Device Errata

Skywire™ Raspberry Pi Adapter

NimbeLink Corp

Updated: July 2017

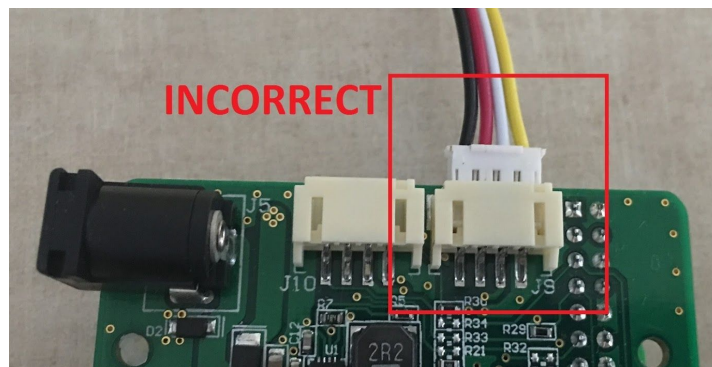
Applications using the Grove connectors on NL-AB-RPI adapter board with PCB revision 1001430 REV A are affected. The grove connector pins are reversed, as shown in the image below. Users who wish to use Grove sensors on affected PCBs must follow the steps outlined in section four of this errata.

Grove sensors using unmodified cables should not be directly attached to the Grove connectors on affected boards as this may cause shorts and/or damage to the sensor or Raspberry Pi.

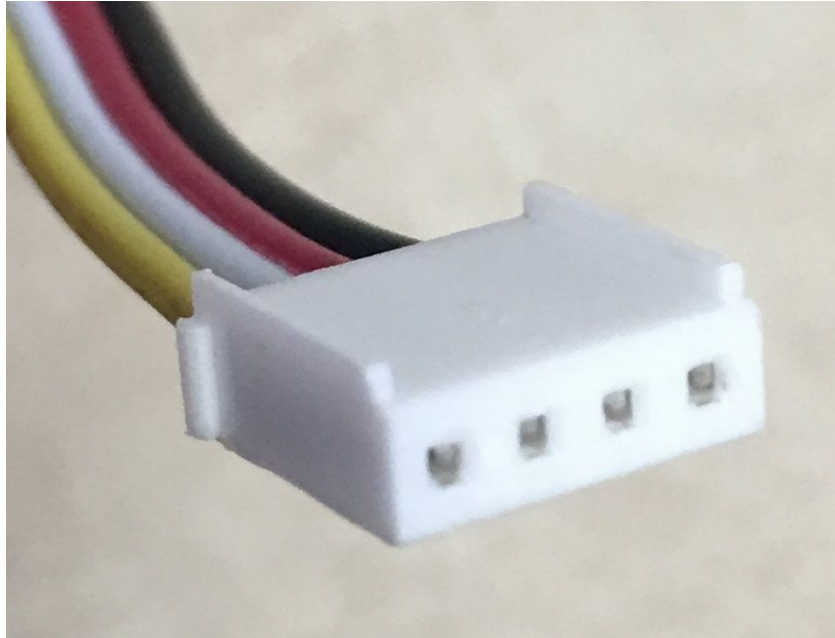
The suggested workaround is to modify the Grove sensor cable connector to allow it to be plugged into the adapter upside down. Users will need to remove the polarity tabs from the Grove connector on the cable. To remove the tabs follow these steps:

1. Identify the side of the cable that will be modified.

2. Use a razor blade to remove the two tabs.
